Reference: Response to Technical Comments and Data Gap Work Plan Addendum

Former Chevron-Branded Service Station 91723
9757 San Leandro Street, Oakland, CA

Subject: Request for Data Gap Work Plan Addendum; Fuel Leak Case No. RO0000412 and Geotracker Global ID T0600101789, Chevron #9-1723; 9757 San Leandro Street, Oakland, CA 94603

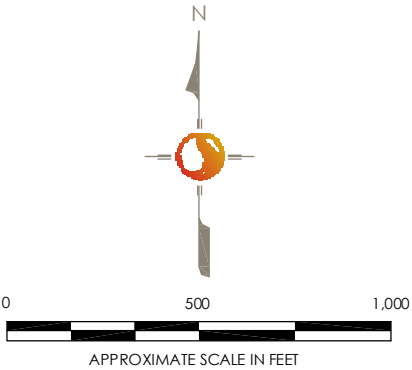
- d. Distance to Existing Water Supply Well** – Up to three water supply wells as close as 100 feet to the site have previously been reported in the immediate vicinity of the site. Although the SCM reports that a well survey was conducted in November 2013; however, a table summarizing, and a figure depicting approximate well locations, was not included. ACEH recognizes that well construction details are confidential; however, a table and figure without these details are appropriate and substantially assist ACEH in determining the suitability of the site to meet this criterion of the LTCP. ACEH requests a tabulation and well location depiction be submitted in the requested work plan addendum below. Please note that all deep constructions (cathodic, extraction industrial, irrigation, recovery,

geotechnical wells, and etc.) within ¼-mile of the site are requested to be included in the summary table and located. All have the potential to act as vertical conduits, and all can be impacted by contamination from the site. Please also be aware that abandoned, non-destroyed, wells may still be vertical conduits. For deep wells proximal to the subject site (especially well P2 and others located within 100 feet of the site), ACEH requests further determination be provided (owner, DWR, ACPWA, etc.) that wells stated or assumed to be abandoned or destroyed are so.

*As requested, a map and table showing all water supply well locations within a 0.25-mile radius of the Site are attached to this letter, along with pertinent, non-confidential details on those water supply wells. Due to the large volume of data that must be sorted through in order to include all well types that have the potential to act as vertical conduits, information regarding the additional wells is not included in **Table 1** or shown on **Figure 2** but will be included in the subsequent investigation report.*
